SUNDRY NOTICES AND REPORTS ON WOOD-HOBBS

7. If Unit or CA/Agreement, Name and/or No.
Myers Langlie Mattix Unit

8. Well Name and No.
#183

9. API Well No.
30-025-26970

OXY USA WTP LP
Myers Langlie Mattix Unit #183
API No. 30-025-26970

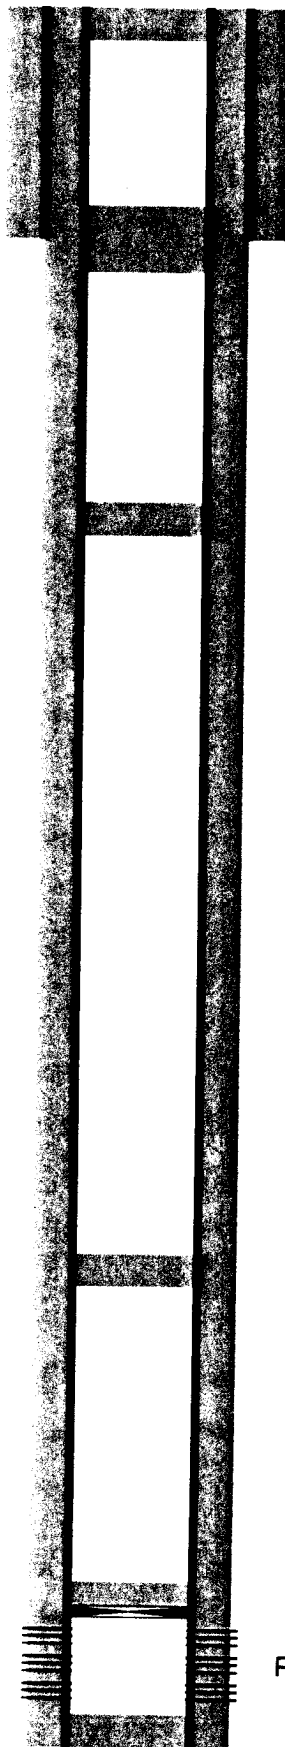
1. Approval is granted to plug this well with the following modifications to the proposed procedure:
2. All plugs below the surface plug should be tagged for casing shoes and the top and base of the salt.

*****All plugs below the surface plug must be at least 100' and 25 sacks of cement.**
